Q&A

VRC 2021-2022: Tipping Point

Tagged: R10

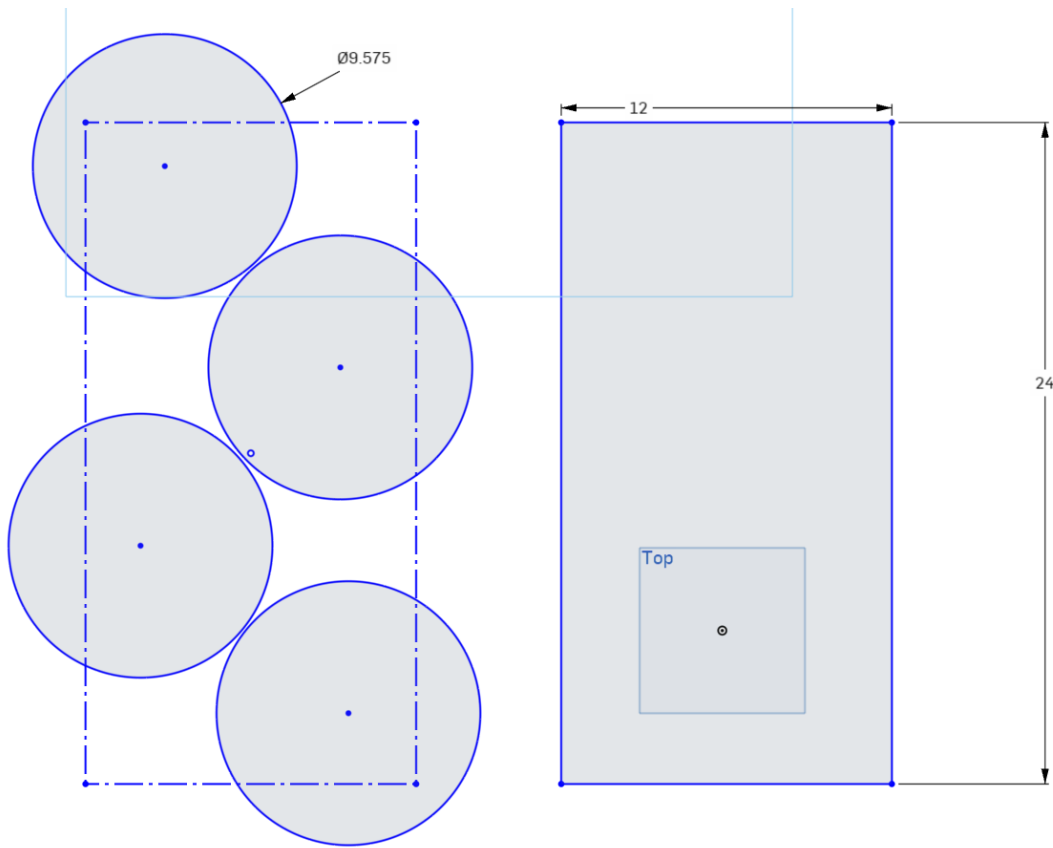
Attached are two images, both rectangles are 12"x24". The highlighted portions of both sheets are equal in surface area, but the left couldn't be reassembled into a 12"x24" sheet.

1. Is the plastic limit based on reassembling parts into a 12"x24" sheet, or is it based on total surface area?
 - a) If it's based on surface area, how are holes within parts accounted for? Are holes/pocketing subtracted from the total surface area of the part?
 - b) How should competitors prove the surface area of complex parts to inspectors and referees?

Thank you for bringing this to our attention and for attaching an example image. It turns out that "theoretically nesting into a single 12"x24" sheet" is *not* functionally the same as the total surface area exceeding 288 square inches. The answer to Q&A 975 has been updated, and R10 will be clarified further in a future Game Manual update.

The former. However, the other portion of the answer from Q&A 975 is still correct - Teams are not required to literally use a single 12"x24" sheet of plastic.
